U_Power_Section
Power_Section.SchDoc
S_REG
A_REG
S_REG
A_REG
U_Audio_Section
Audio_Section.SchDoc
#12-P
#13-P
#14-P
#15-P
#12-P
#13-P
#14-P
#15-P
#O_MIC
#O_MIC
U_Battery management Section
Battery management Section.SchDoc
CHG
B_ADC
CHG
B_ADC
U_Sensor_Section
Sensor_Section.SchDoc
SDA_
SCL_
LED#
CLED
SDA_
SCL_
LED#
CLED
U_SourceSelector_Section
SourceSelector_Section.SchDoc
S_SENS
S_SENS
U_Connector_Section
Connector_Section.SchDoc
RX
TX
RTS
DTR
RX
TX
RTS
DTR
AC_LINE
AC_Neutral
AC_LINE
AC_Neutral
U_Controller_Section
Controller_Section.SchDoc
#12-P
#13-P
#14-P
#15-P
#12-P
#13-P
#14-P
#15-P
CHG
B_ADC
#O_MIC
CHG
B_ADC
#O_MIC
RX
TX
RTS
DTR
RX
TX
RTS
DTR
SDA_
SCL_
SDA_
SCL_
LED#
CLED
S_REG
A_REG
S_SENS
LED#
CLED
S_REG
A_REG
S_SENS
U_Supply_Section
Supply_Section.SchDoc
AC_LINE
AC_Neutral
AC_LINE
AC_Neutral

Power Section

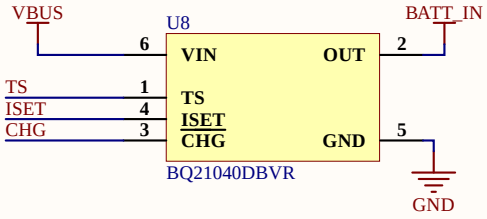
Place Decoupling Capacitor with there respective pins.

ISET Resistor Value is changed in Parameters, please be careful.

Battery Charging Section

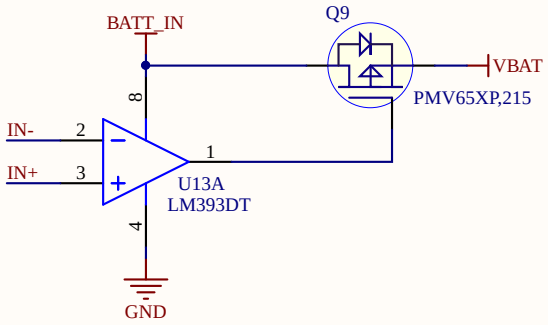
As per Datasheet, the value should not exceed 675 Ohm.

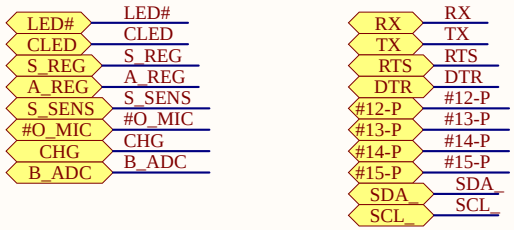
External Enable wouldn't be used as Development board already had circuit.

Controller Section

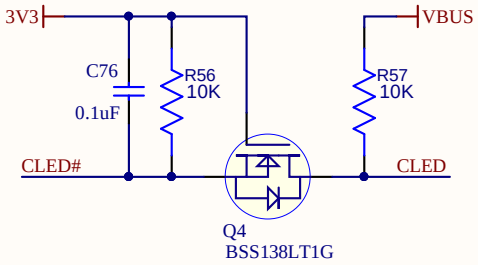
SW2 is being used for Software Reset.

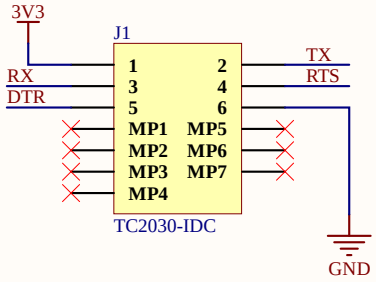
Mentioned Capacitors will be placed with Battery Connector and with USB Main Connector.

No Need to place Decoupling Capacitors with Switch as this is just path.
